Planning Commission

Regular Meeting Agenda
August 14, 2023 | 6:30 PM
Peachtree City City Hall

Planning Commission of Peachtree City
Meeting Minutes
Monday, July 24, 2023
6:30 PM

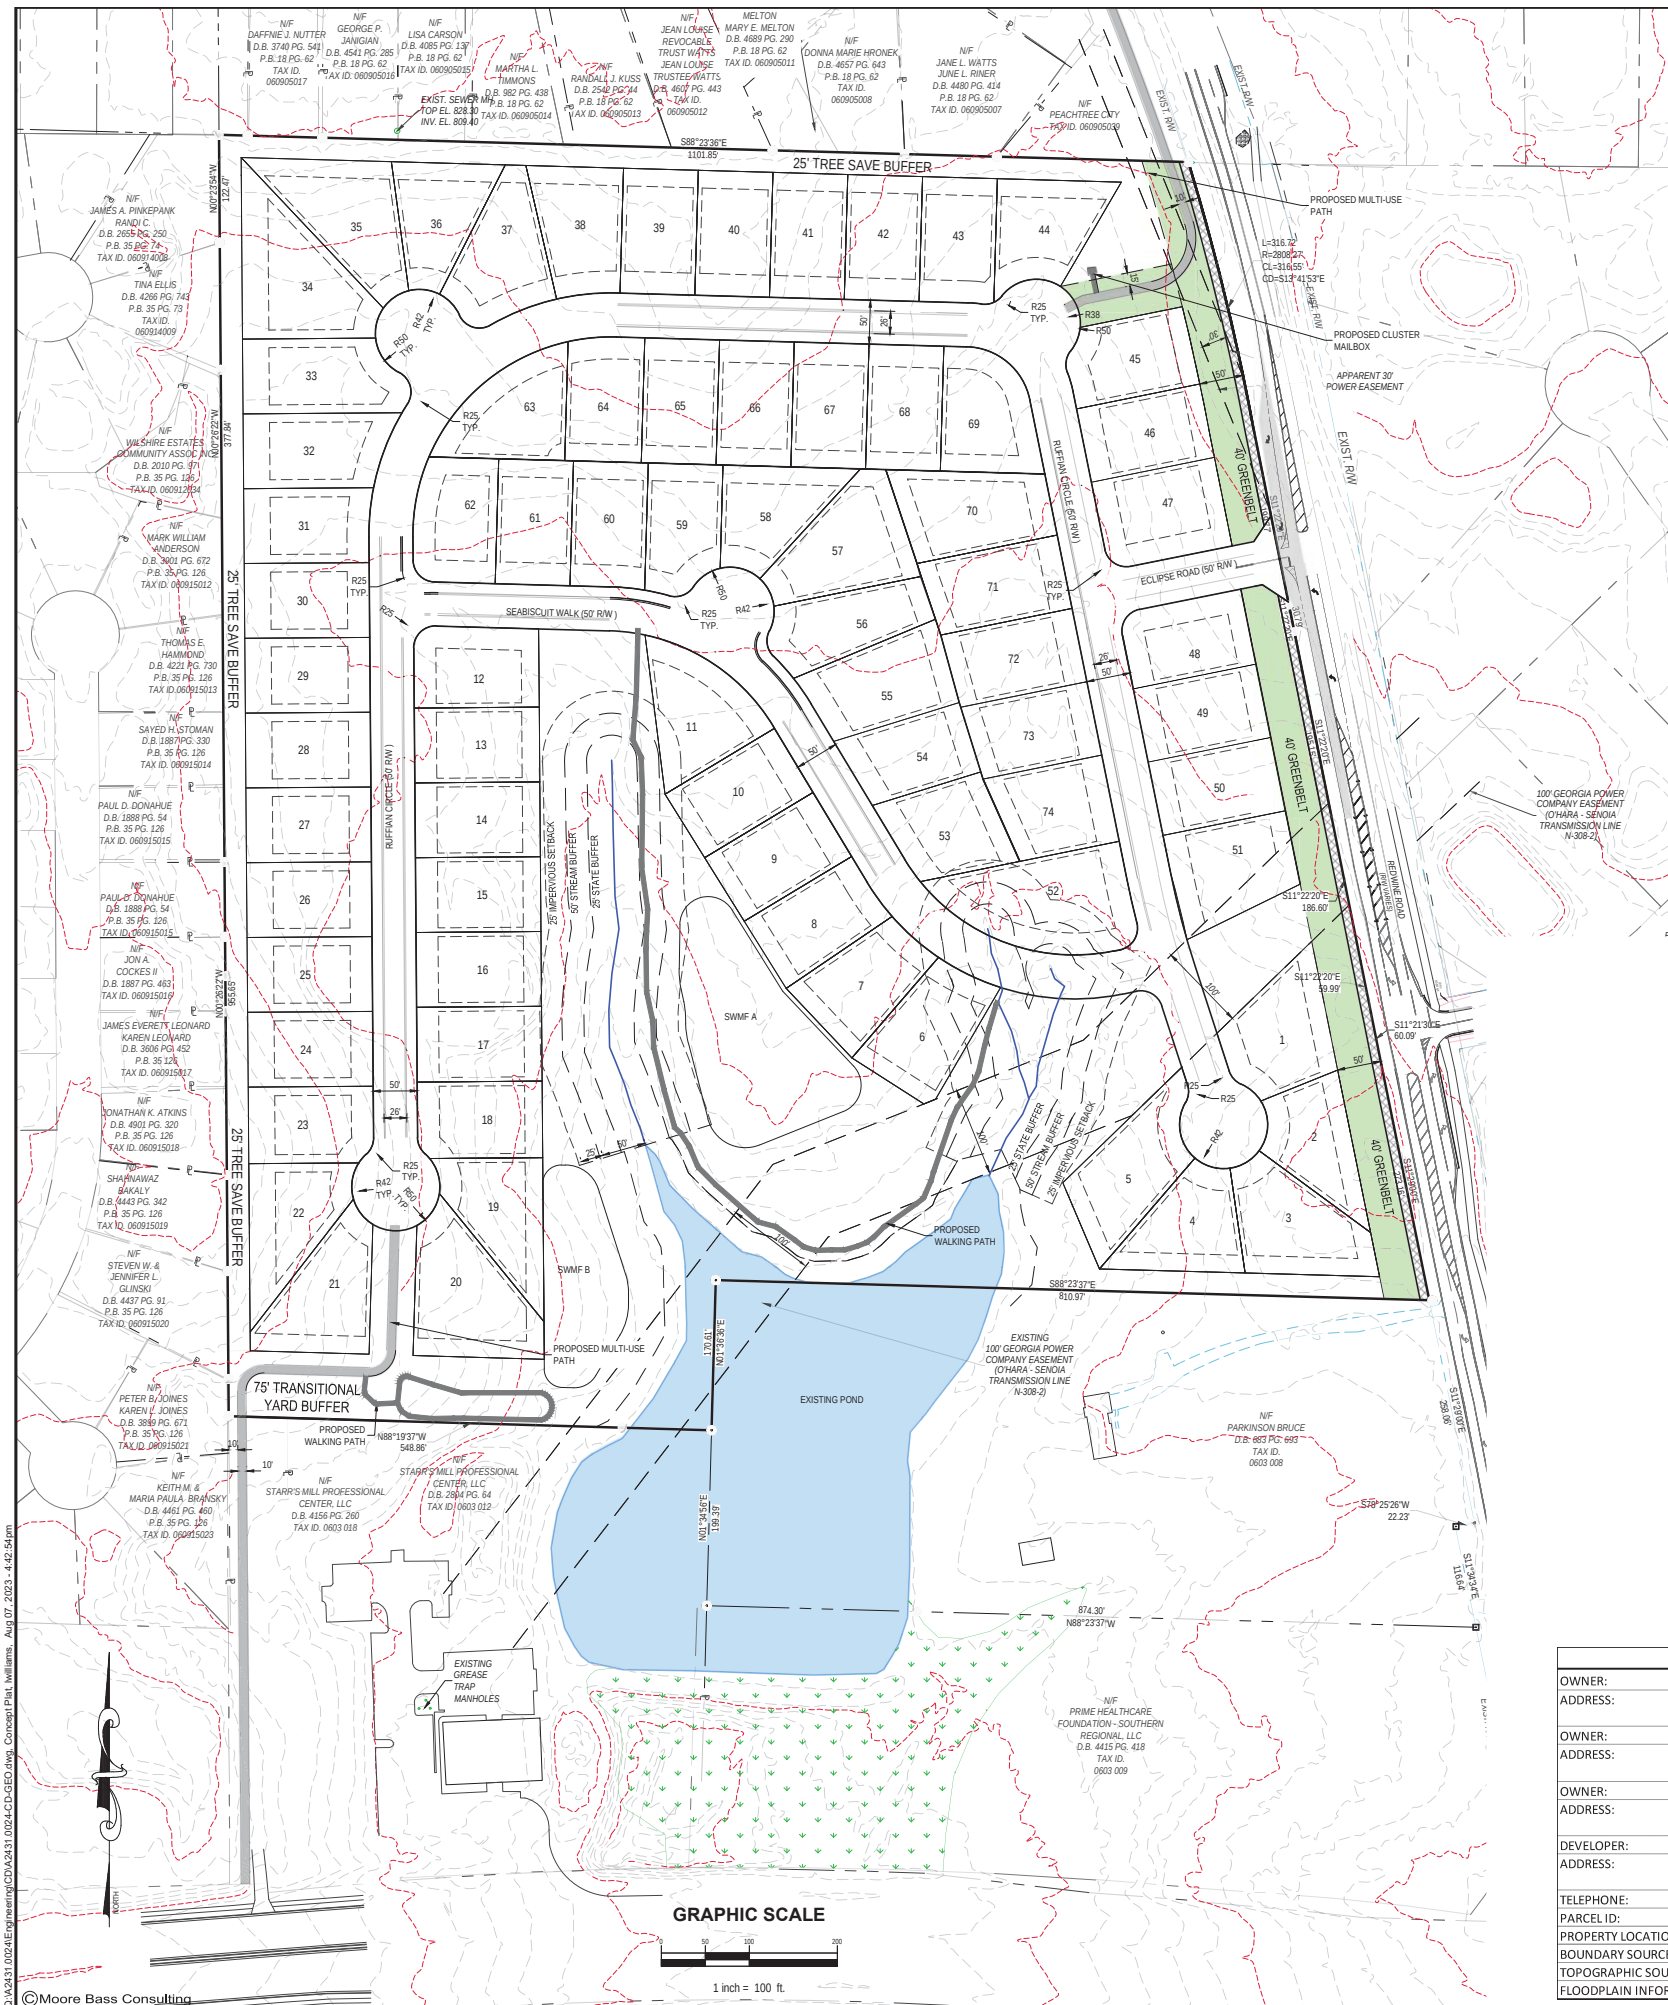
Staff notes that the Inset detail on the plat for Lots 22-44 shows the correct setbacks, and satisfies conditions number 2-4 above. For condition number 8, the buffers shown on lots 52 and 6 are for reference only and will not be on the final plat for these lots due to the approved stream impacts permitted by the Army Corp of Engineers and GA EPD.

Staff has reviewed the proposed plat and determined that all conditions are satisfied on the document.

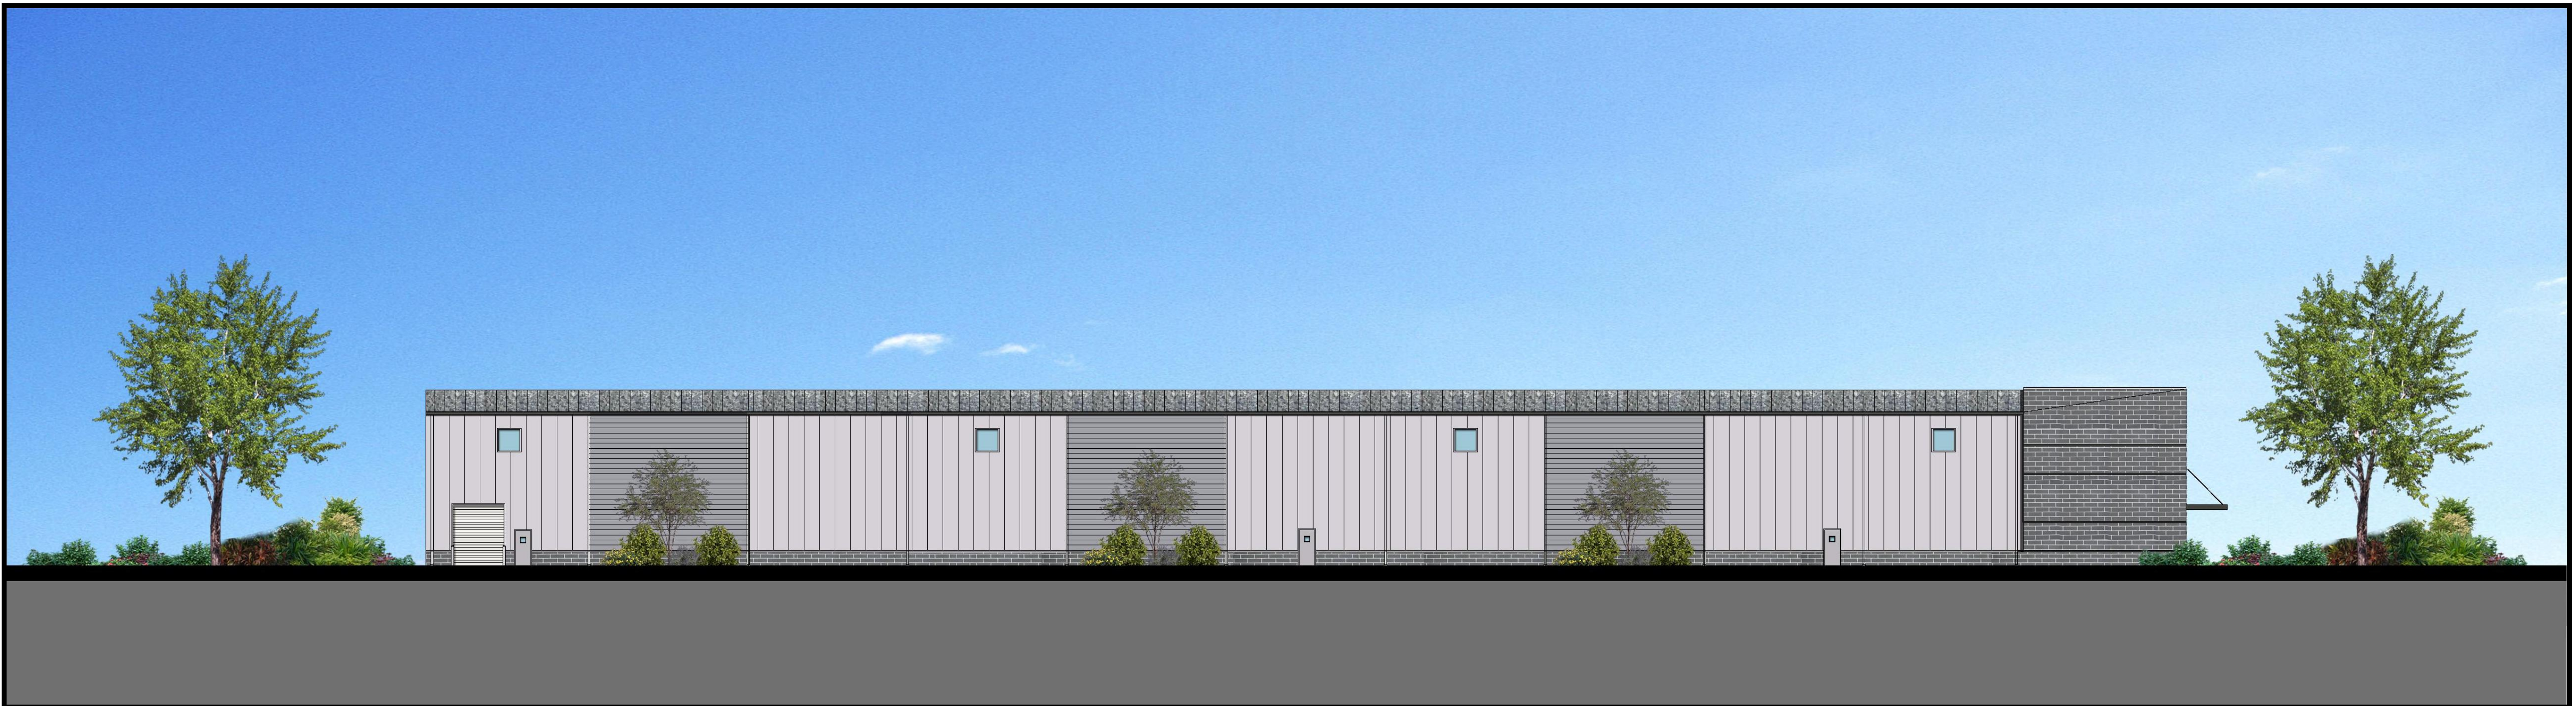
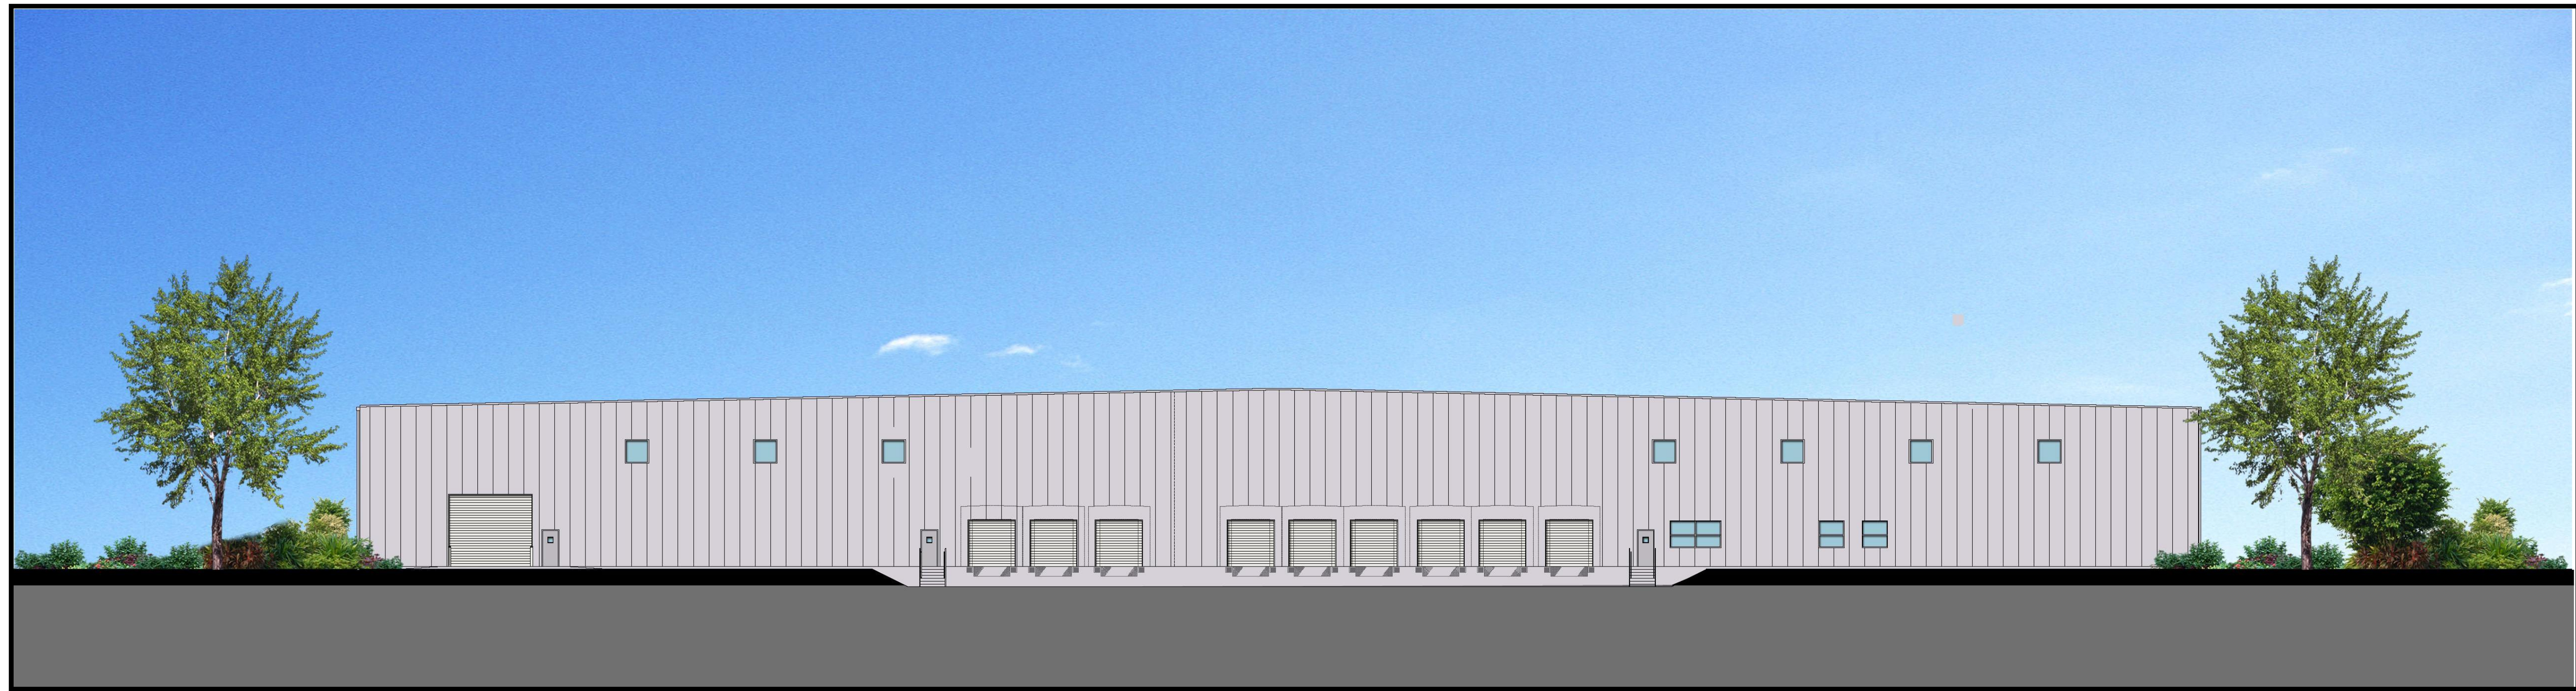
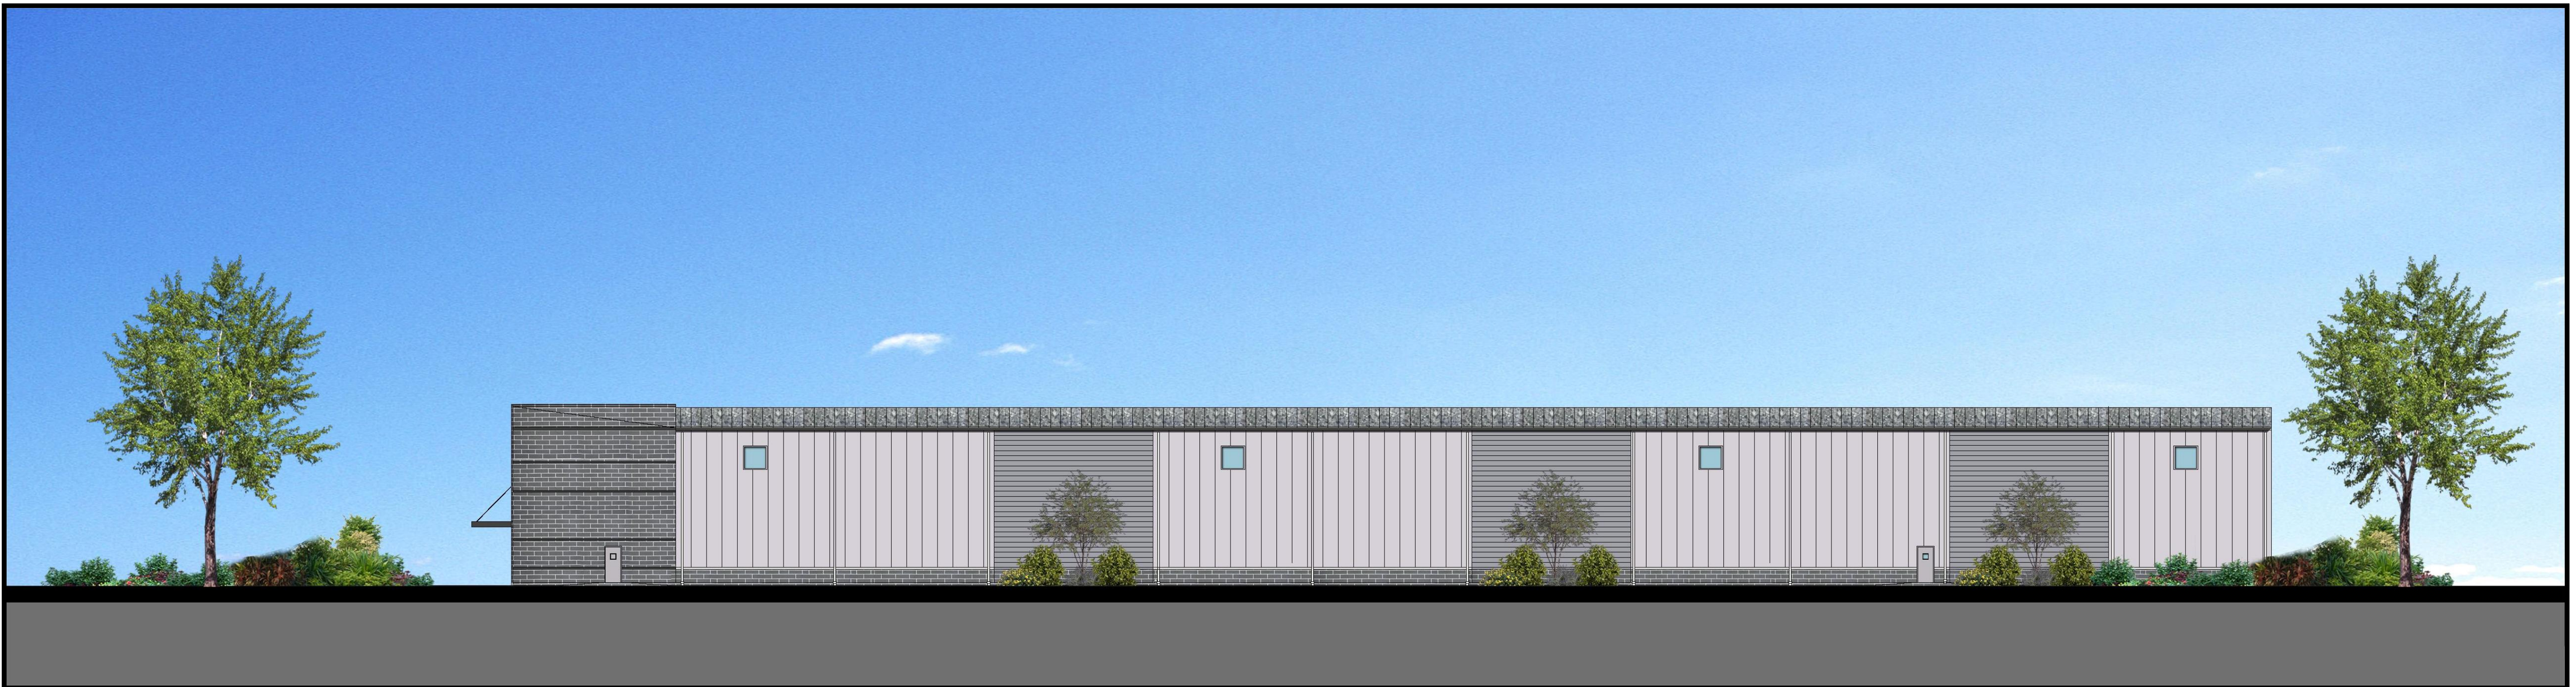
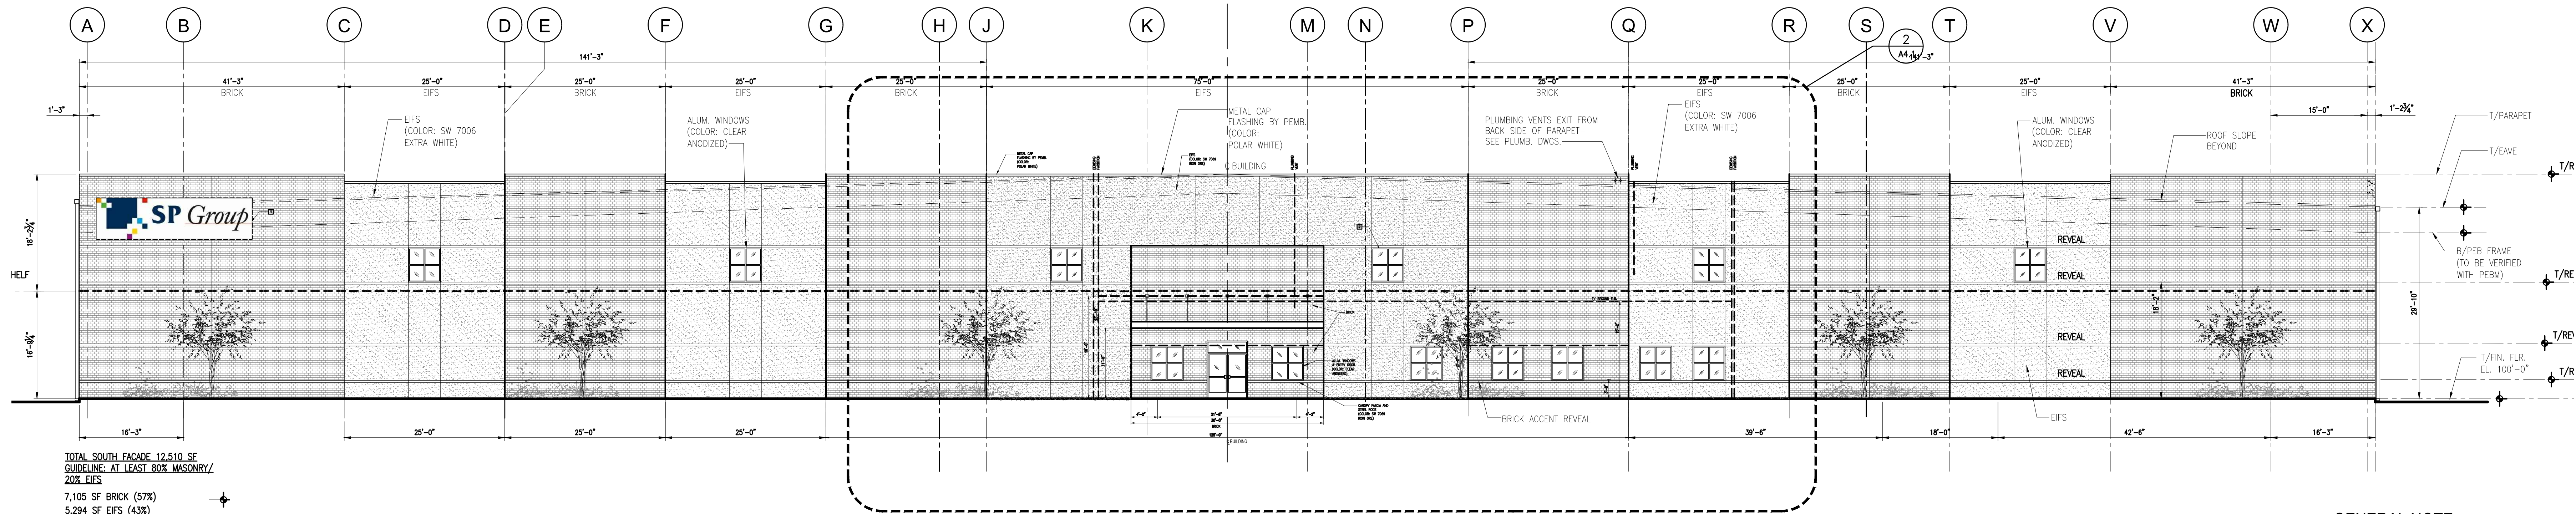
The applicant does address the "shall" statement in the ordinance of not having a blank wall facing a street, and the proposal calls for a brick wrap and base for the metal siding where the building may be seen by the public on the side facades. However, the proposal does not satisfy all the "should" statements in the ordinance and the proposed color does not blend with the natural surroundings. Therefore, approval or denial of agenda item 23-08-04 is at the discretion of the Planning Commission.

For this proposal, the front facade is broken up into 25-foot sections differentiated by a change in materials as well as a change in plane and height for added visual interest. High windows accent every other section. The building entry is emphasized with a brick surround, ground level windows, and a canopy giving it a more human

Also among the materials listed in Sec. 727 are mill-finish (non-colored) aluminum metal windows or doorframes. The applicant is proposing the front windows and entry door be clear anodized aluminum. While the windows and door are not proposed to have color, they are proposed to be treated with a clear finish that makes them stronger and more durable. Should the Planning Commission approve the building elevations, staff recommends the windows and door be painted to match the canopy.

Sec. 728 of the LDO states that facade colors should be low reflectance, and subtle, neutral, or earth-tone colors. The applicant is proposing a white and gray color palette with dark brick. Should the Planning Commission approve the building elevations, staff recommends the applicant work with the planning department to select an alternative color for white that has a lower reflectance, such as off-white, ivory, or gray.

Should the Planning Commission approve the building elevations, staff recommends the following conditions be considered for adoption:
